MARKHAM ST. JUMP START IMPVTS. (CONWAY) (S) F.A.P. STPU-9095(33) ARDOT JOB 080566

MARKHAM ST. JUMP START IMPVTS.
(CONWAY) (S)

REV.	DATE	DESCRIPTION
Δ	10/14/2019	CHANGE ORDER NO. 1 - REVISE INDEX OF SHEETS

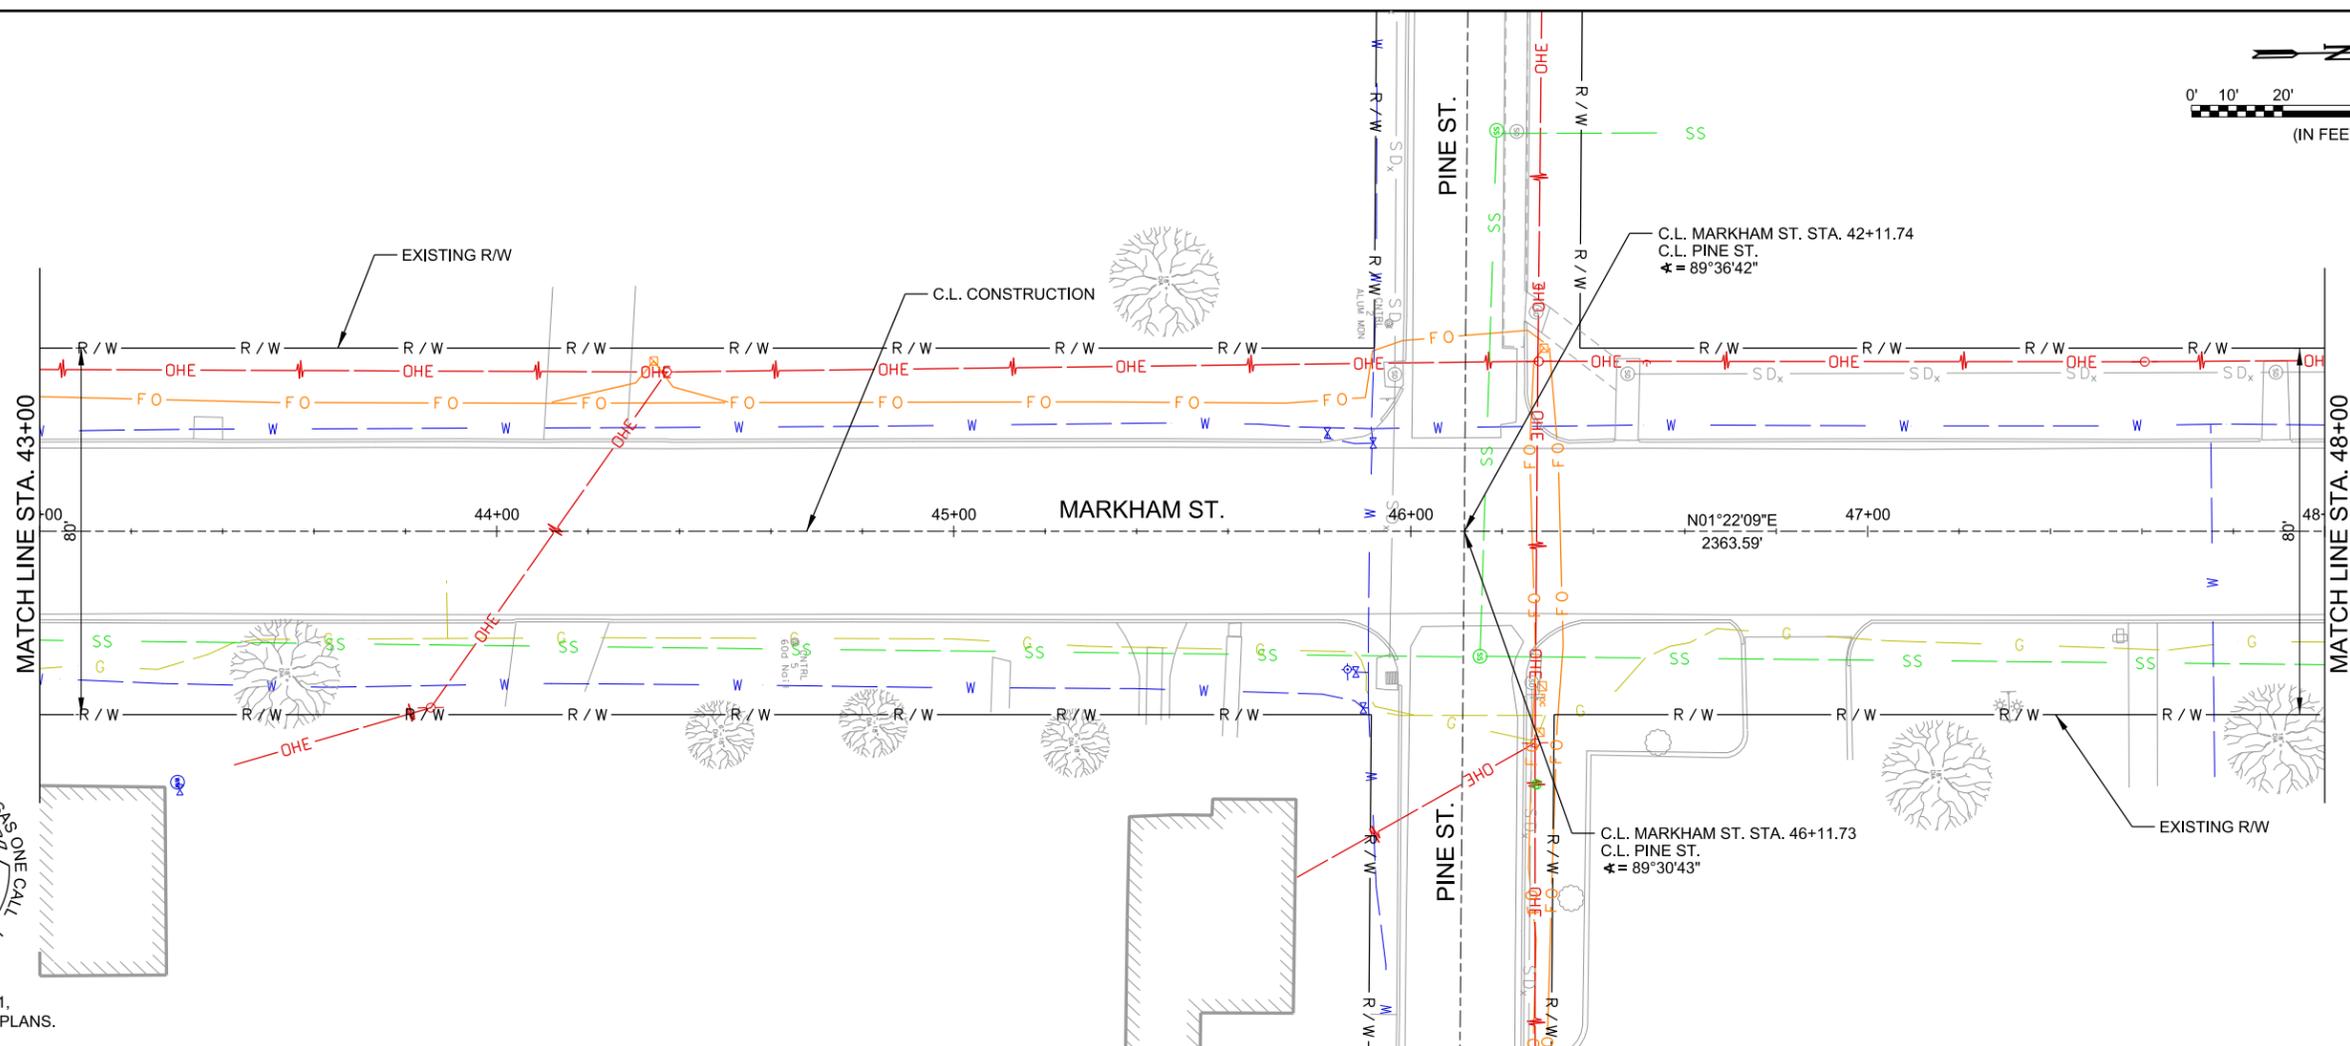
REV.	DATE	DESCRIPTION	BY
Δ	10/14/2019	CHANGE ORDER NO. 1 - ADD MILL & OVERLAY	DLT
